Ensuring Data Integrity on the i.MX35 EMI

by *Multimedia Applications Division*
Freescale Semiconductor, Inc.
Austin, TX

This Engineering Bulletin explains the technique required to minimize the size of these transient pulses in i.MX35-based designs to ensure SDRAM data integrity. The following devices are affected by this document:

Figure 1. Representative Scope Trace of Transient During a Write Cycle

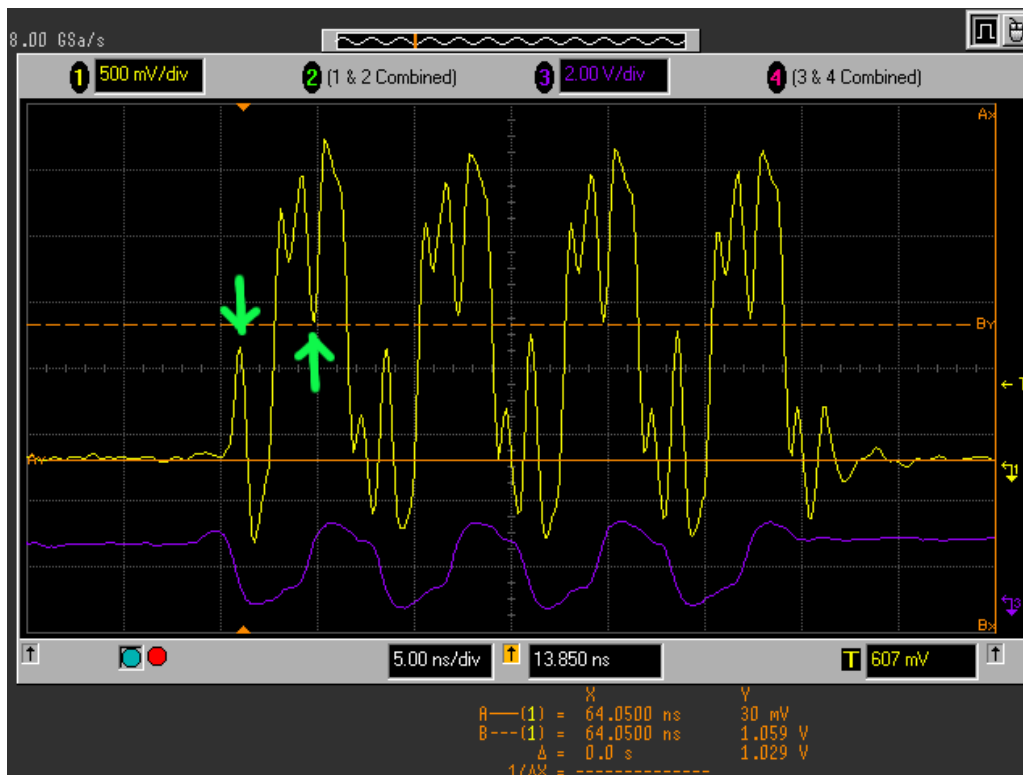
The first two transients corresponding to the two written words are marked in Figure 1 with green arrows. The horizontal cursor marks the highest positive-going transient in the burst. In this plot, the transient magnitude is 1.029 V, which exceeds the maximum VIL ($0.3 \times NVCC_EMI$) for mDDR memory. Although the thresholds are different for DDR2 memory (dynamic limits relative to Vref), errors may still

Figure 2. Partial Wire Bond Diagram Showing Inner and Outer Wire Bonds

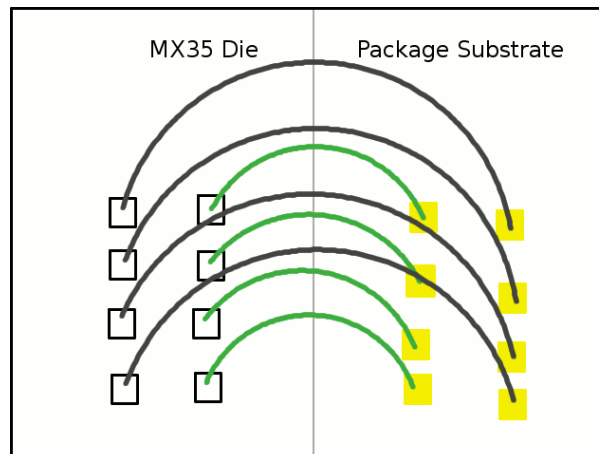
The physical configuration of the two rows of bond wires is similar to a cross-section of the windings in a transformer. As such, coupling occurs due to the proximity of the bond wires to each other. As a result, currents can be induced in adjacent bond wires when a significant quantity of the external memory interface signals simultaneously transition in the same direction. This is not generally an issue for signals that transition in sync with each other (where the edges are aligned), but the DQSx signals are data strobes that do not transition when the data lines are transitioning and vice versa.

The transients on the DQSx signals observed in the TO1.0 and TO2.0 silicon revisions of the i.MX35 device arise as the cooperative result of the skewed transition edges along with the fact that these silicon revisions use the longer, more inductive, outer set of bond wires for all the DQSx signals.

- DQSx signals are bonded with the shorter, inner row of bond wires
- Substrate routing between the bond and ball pads is greatly improved
- Twenty three signals are shifted to move the DQSx signals closer to the power supply balls

For the first improvement, the die of the i.MX35 was modified such that the DQSx signals could be bonded on either the inner or outer pad ring of the die to allow the same die to be packaged into either ball map of the device. The advantage of this modification was that existing die probing hardware can continue to be used while greatly reducing the length and inductance of the bond wires that connect the DQSx bond pads to the substrate in the new package. As a result, the inductive coupling effect is greatly reduced.

Figure 4. Partial Schematic of Filters Placed on DQS[0:3], SDCLK, and SDCLK_B Signals

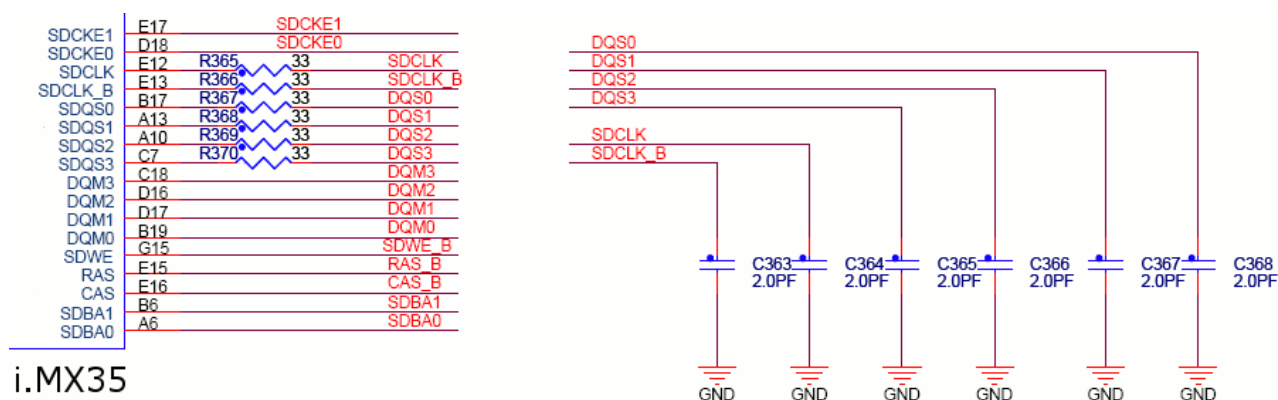
For existing, qualified designs using the TO2.0 silicon revision, the addition of transient suppressing RC filters to all four DQSx signals as well as the SDCLKD and SDCLK_B lines is recommended. These filters consist of a series resistor with a capacitor placed as closely as possible to the memory device. The filtering scheme used on the i.MX35 mDDR CPU card is shown in a partial schematic in Figure 4.

For the i.MX35 mDDR CPU card, the component values chosen were a series resistance of 33 Ω and a termination capacitance of 2 pF. The RC filters were added to the SDCLK and SDCLK_B clock lines to keep any skew between the DQSx signals and these clock lines to a minimum.

Figure 8. Scope Capture of DQS0 with T02.1 Silicon

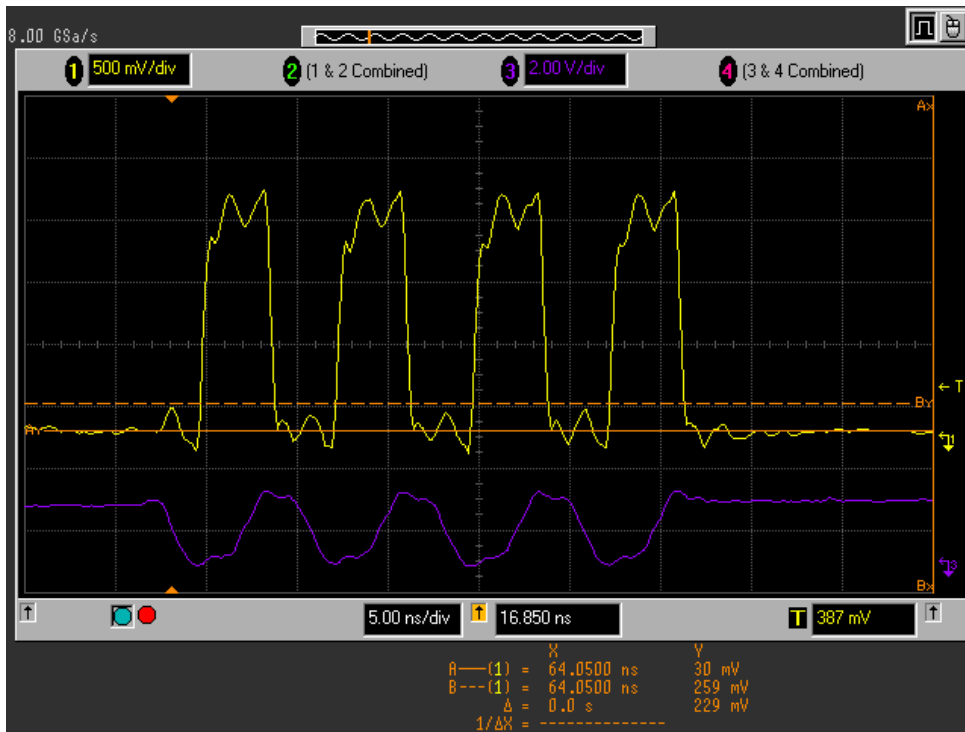
The i.MX35 mDDR CPU card was re-laid out for the TO2.1 silicon revision ball map with minimal changes to the existing filtered mDDR board layout. Figure 8 shows an oscilloscope capture of the DQS0 signal from the revised TO2.1 mDDR CPU card with the drive strength set to SDRAM/MAX for the data

lines and MDDR/HIGH for the remainder of the EMI signals. The transient level is reduced by half again as much as the filtered TO2.0 DQS0 signal seen in [Figure 5](#).
